**COUNTY OF VENTURA
PUBLIC WORKS AGENCY**

Addendum No.1

Subject: **tšumaš Creek Improvements Hueneme Road to Upstream of Jane Drive.
Specification No. WP21-01; Project No.: 82323
Bids to be Opened Thursday, October 15, at 2:00 PM**

SAVE DATE: 9/22/20 MUJLEB, JOHN K:\PROJECTS\ZONE2\TŠUMAS\CHUMASH\CREEK\82323 TŠUMAS, CREEK, HUENEME RD - JANE DR\DESIGN\DESIGN\DRAWINGS\FINAL PLANS\CROSS SECTIONS STA 37+50 TO 41+00.DWG

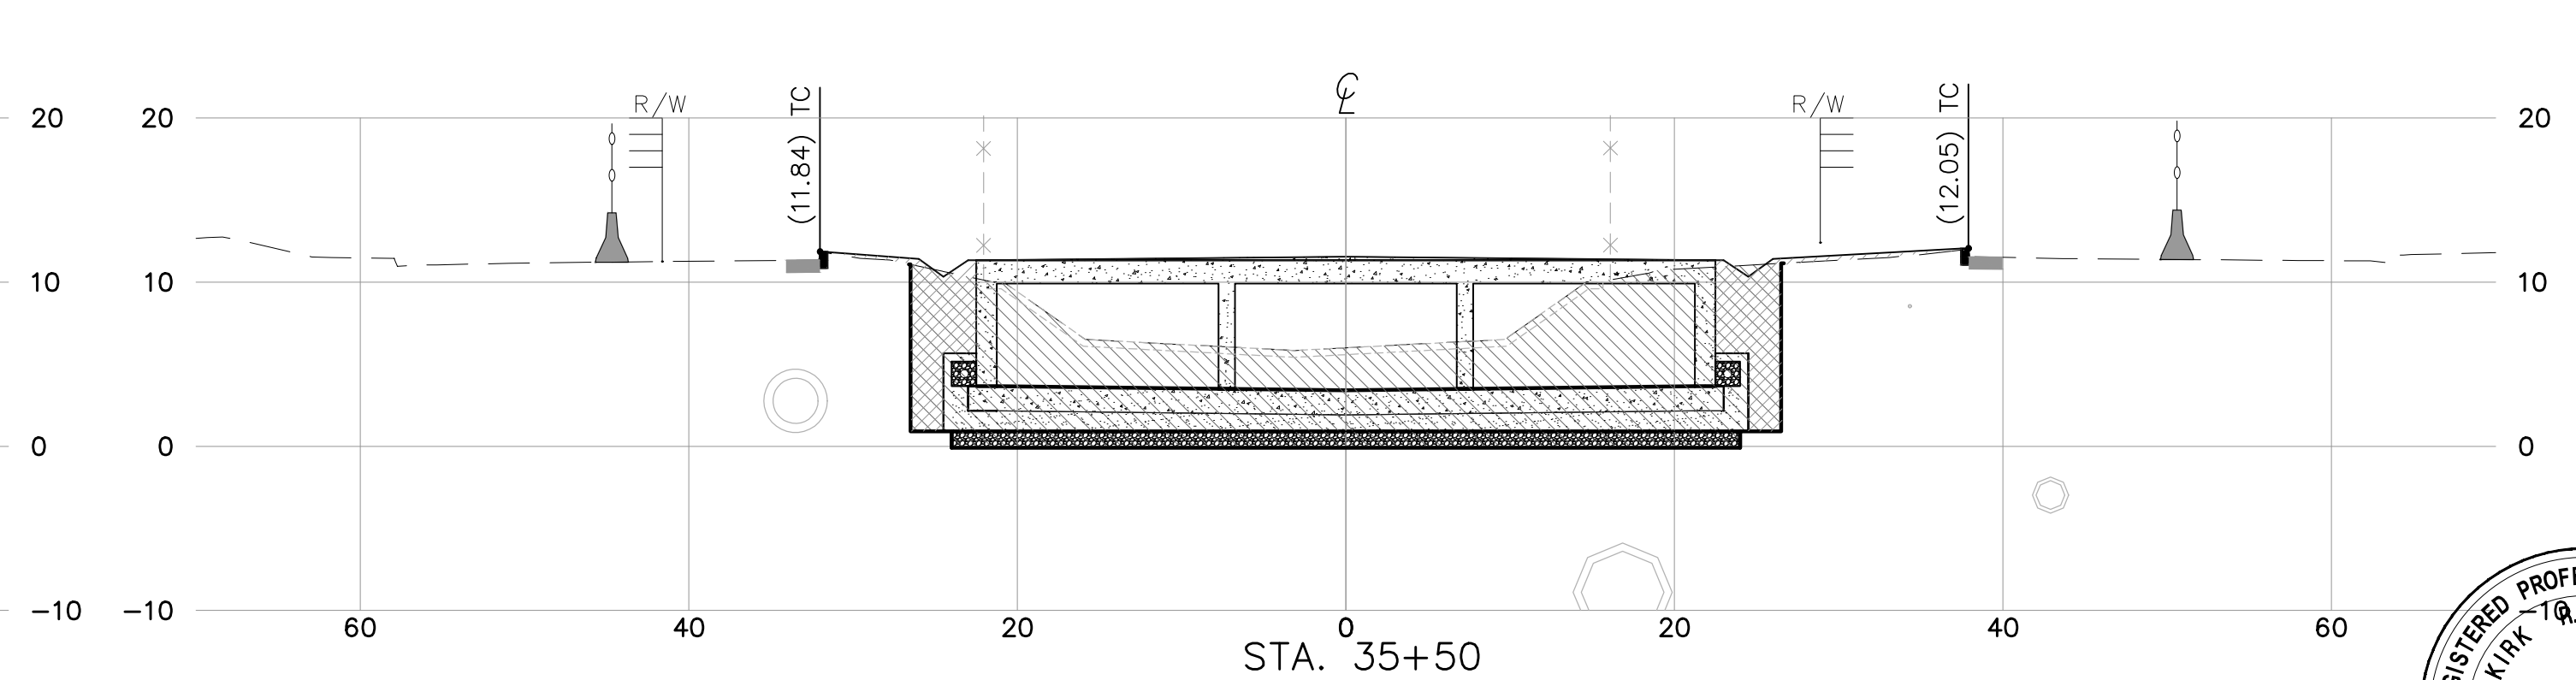
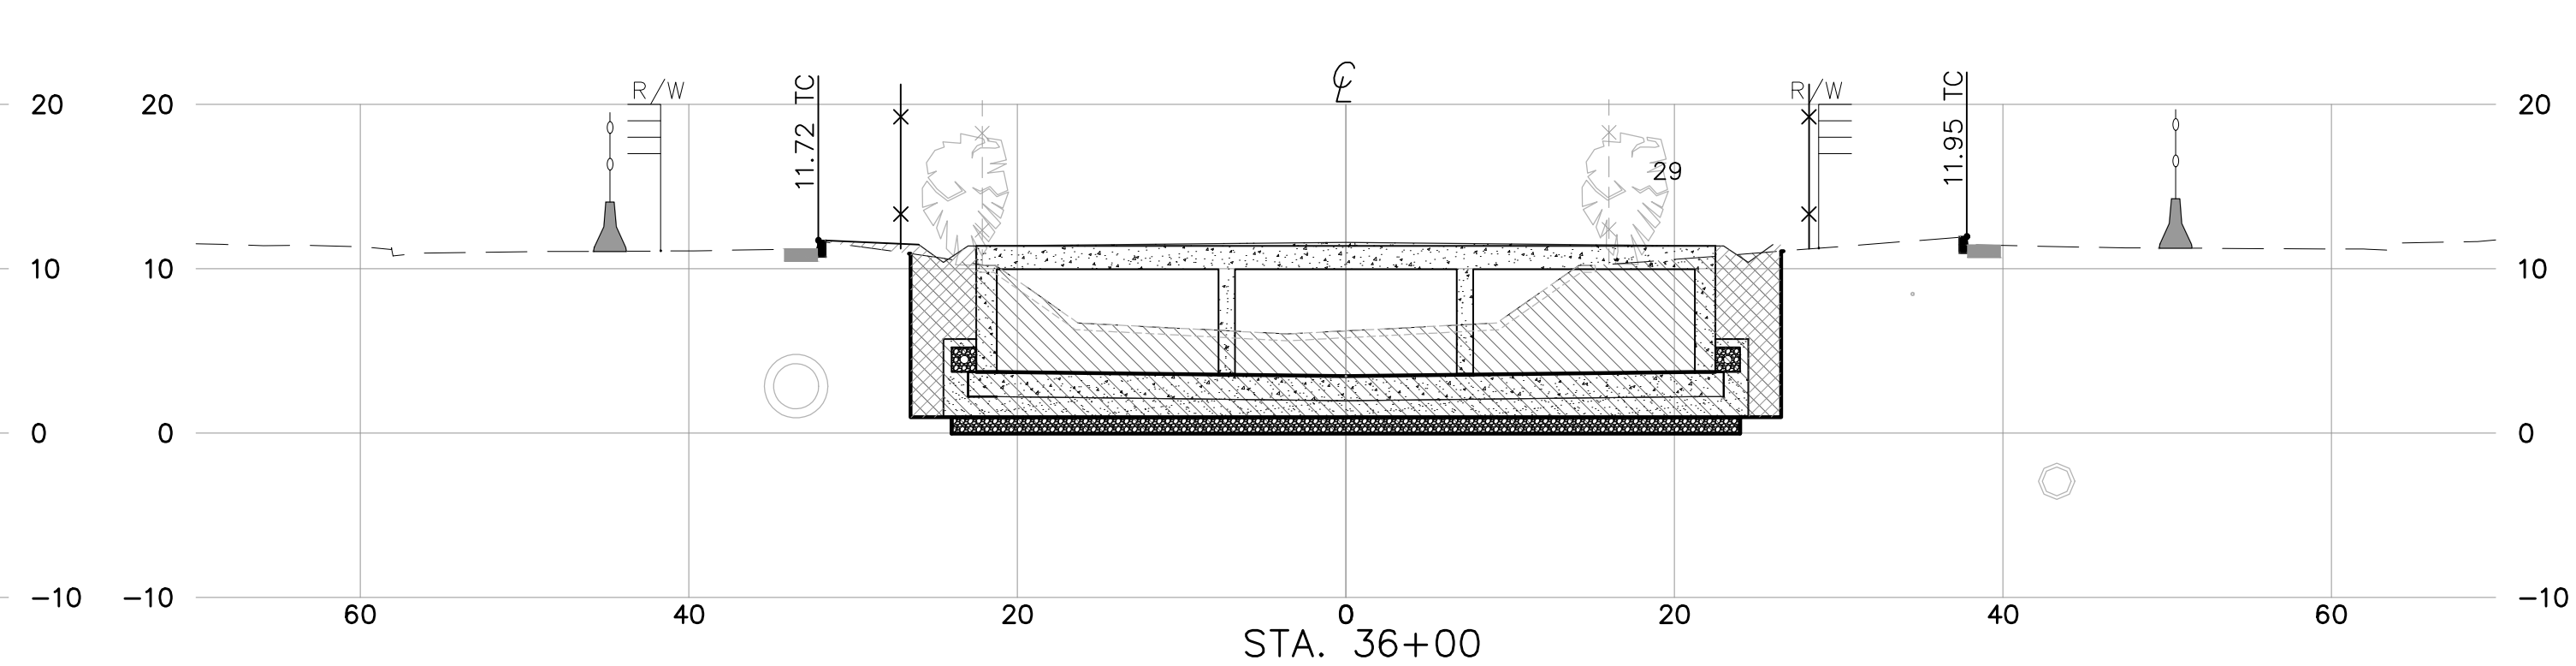
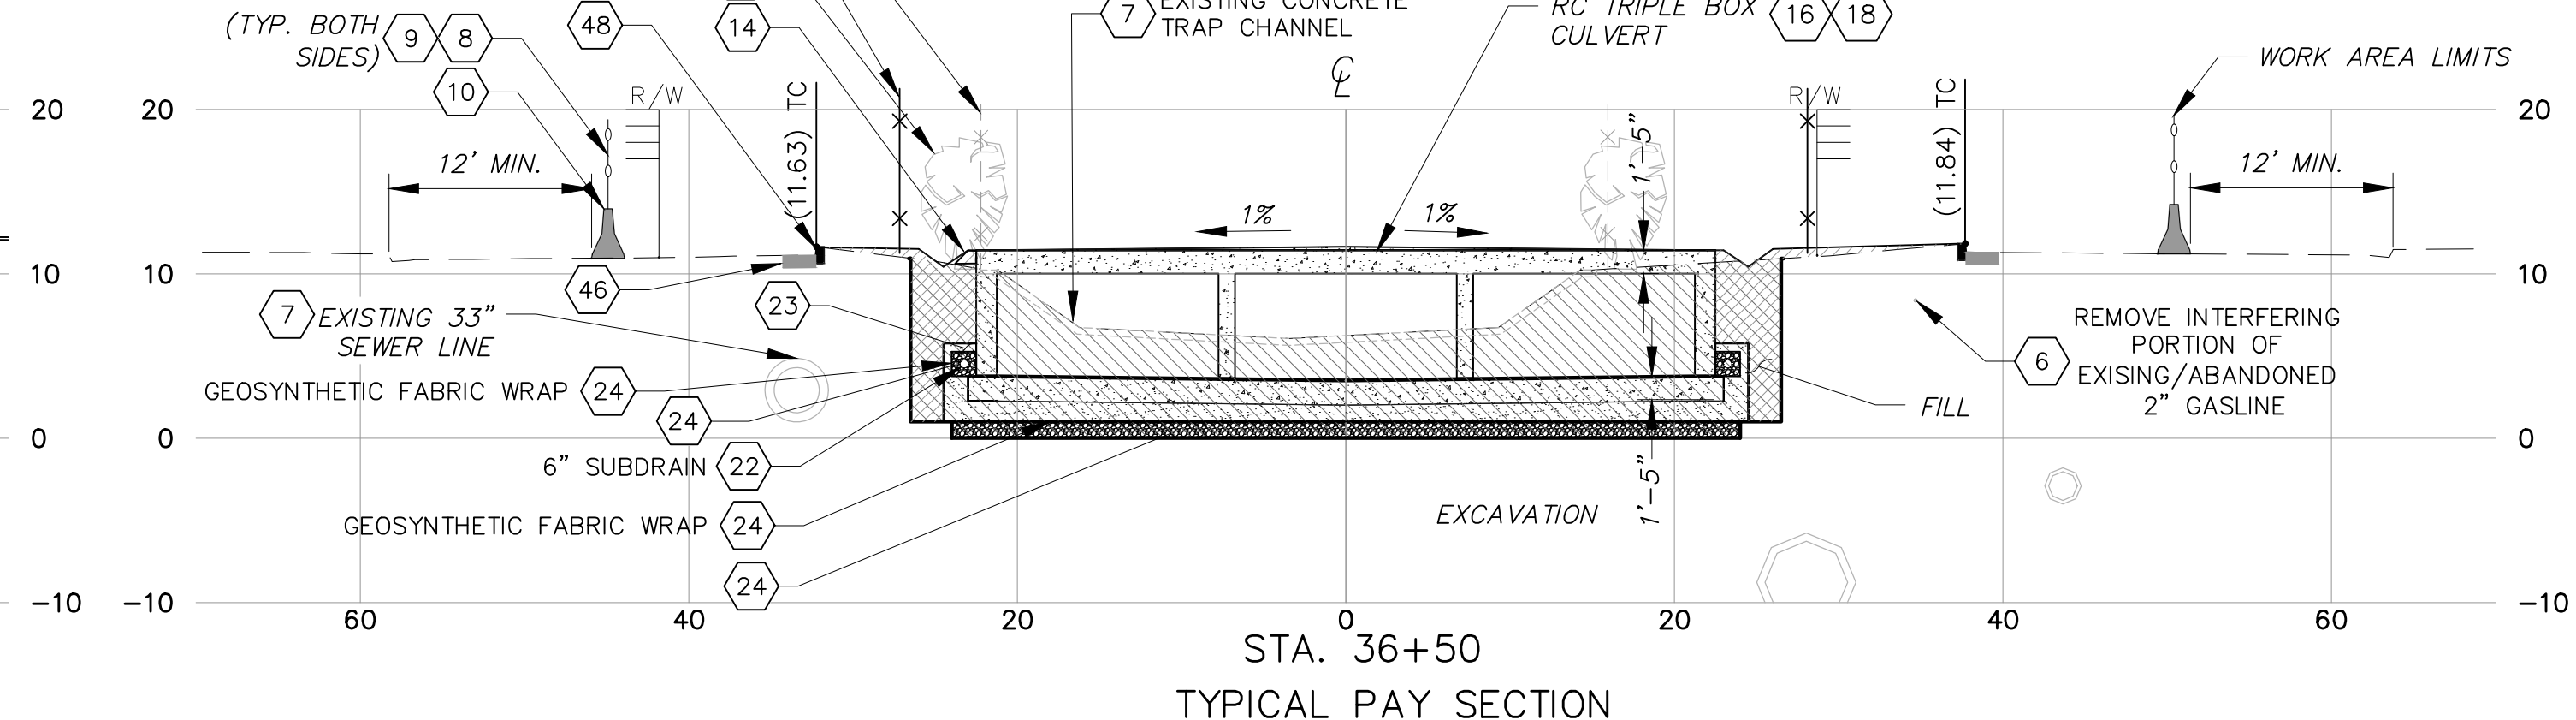
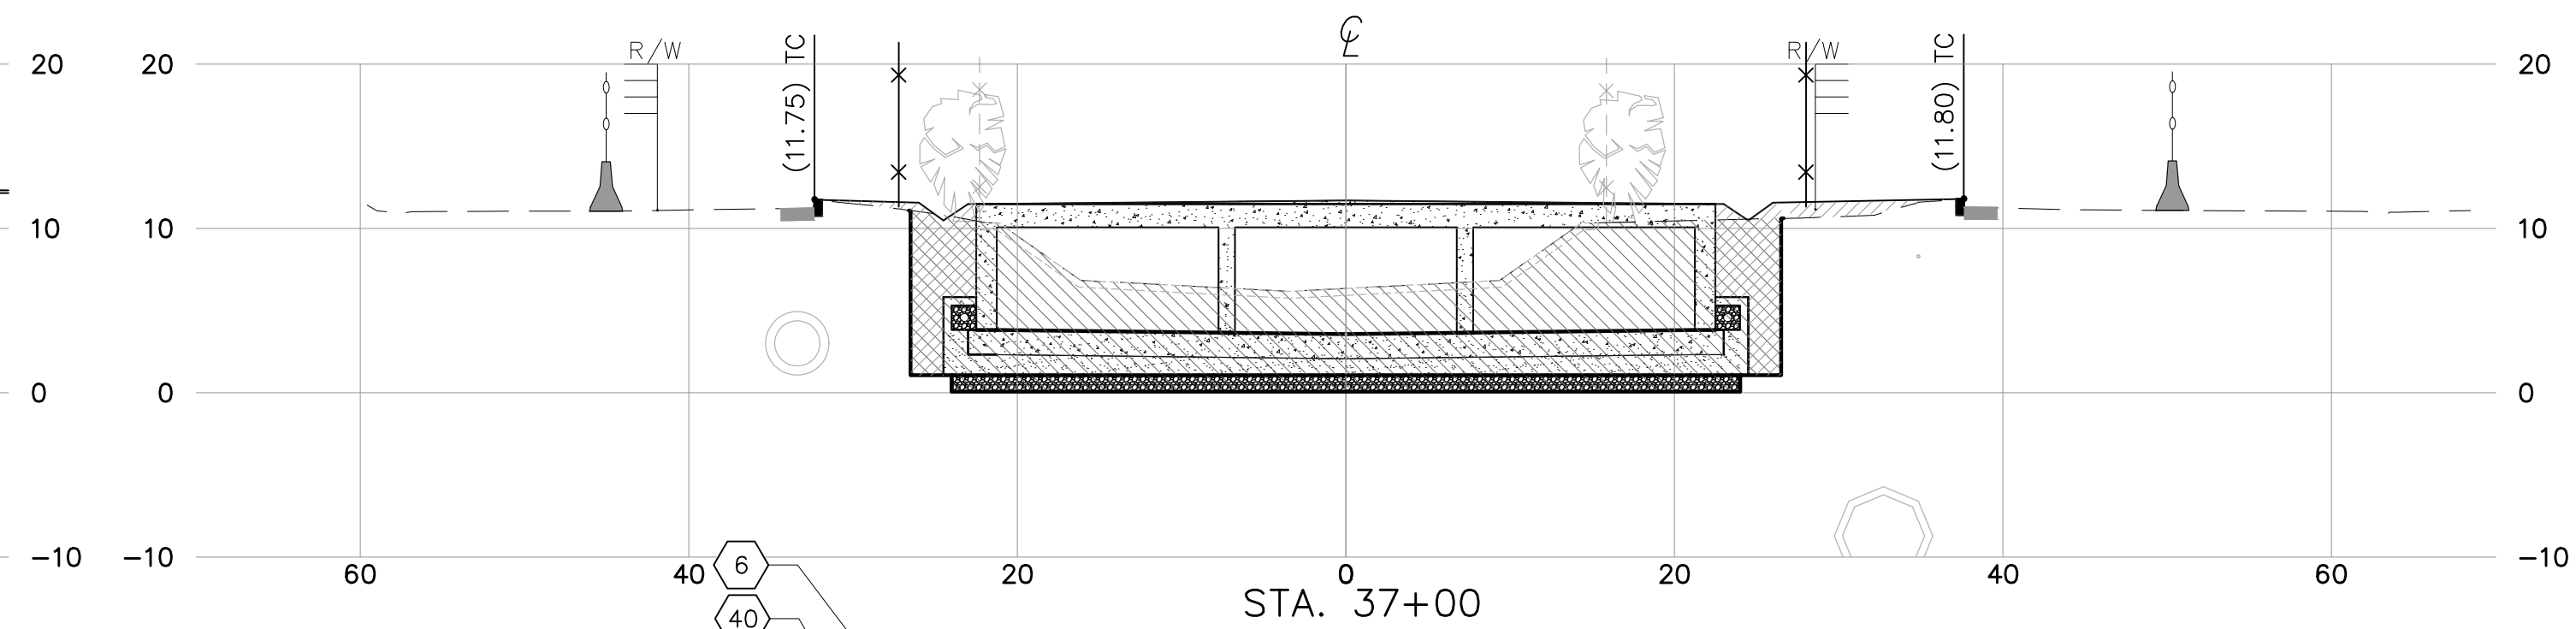
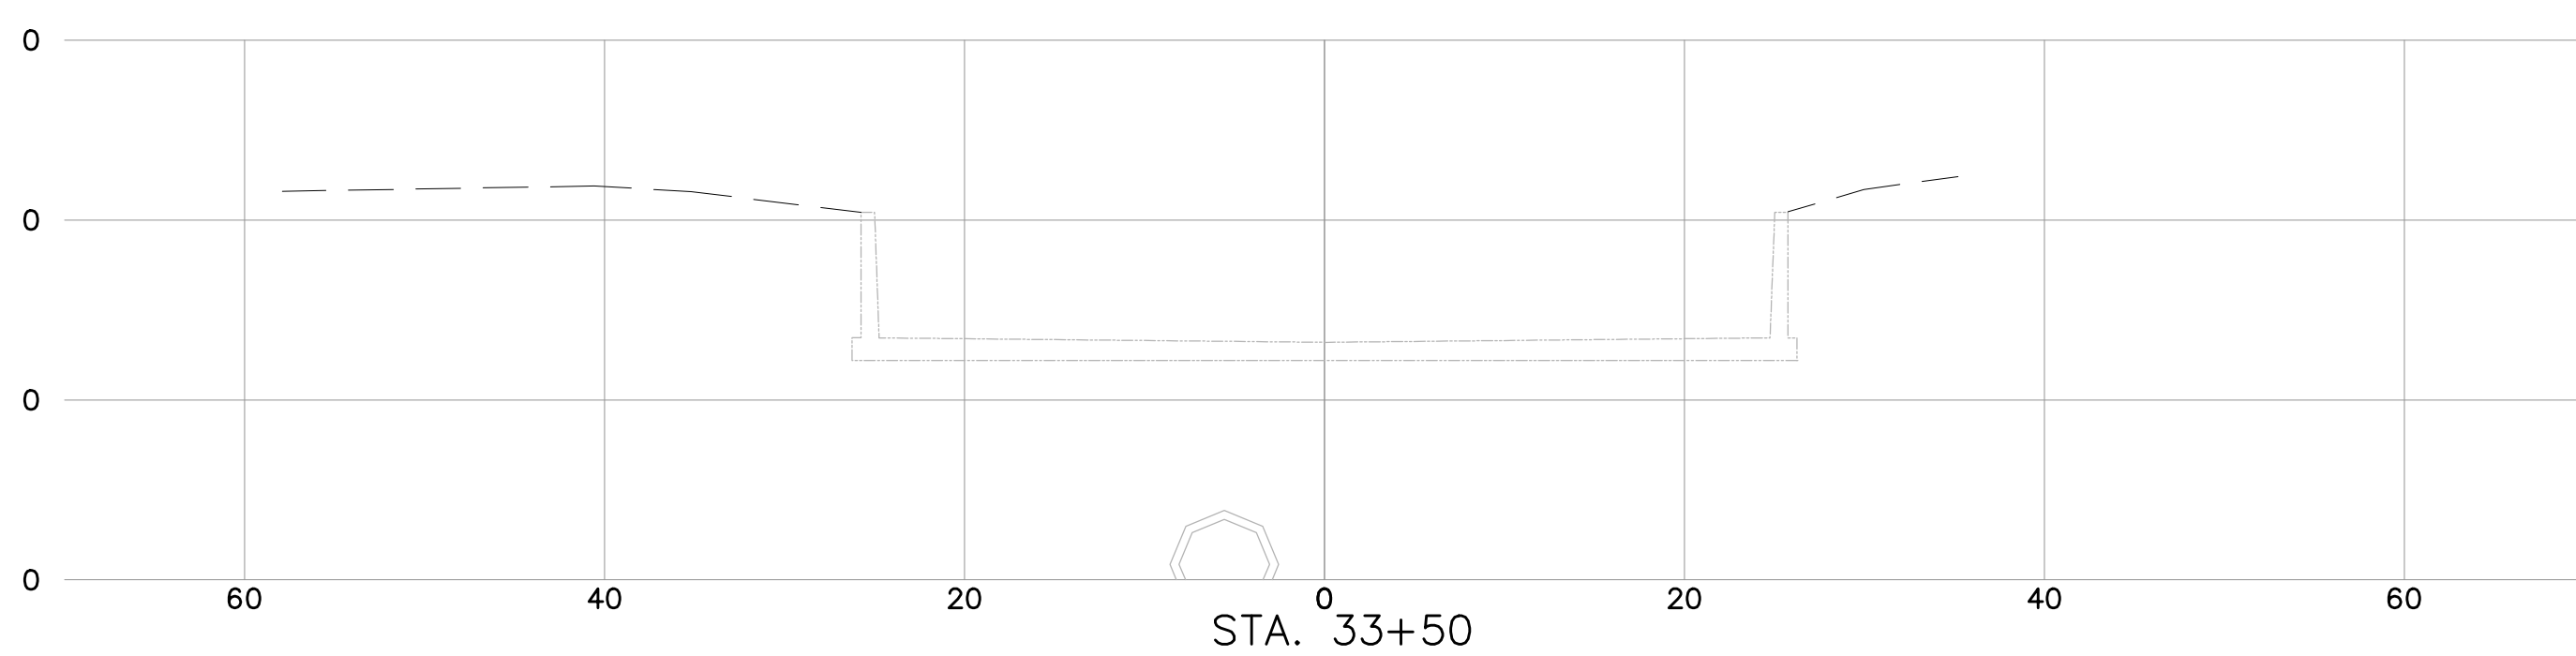
10. Replace sheet 25 OF 30, "CROSS SECTIONS STA 37+50 TO 41+00" with the attached, revised sheet 25 OF 30 to update with the new subdrain detail.
11. Replace sheet 26 OF 30, "CROSS SECTIONS STA 41+50 to 42+40" with the attached revised sheet 26 OF 30 to update with the new subdrain detail.
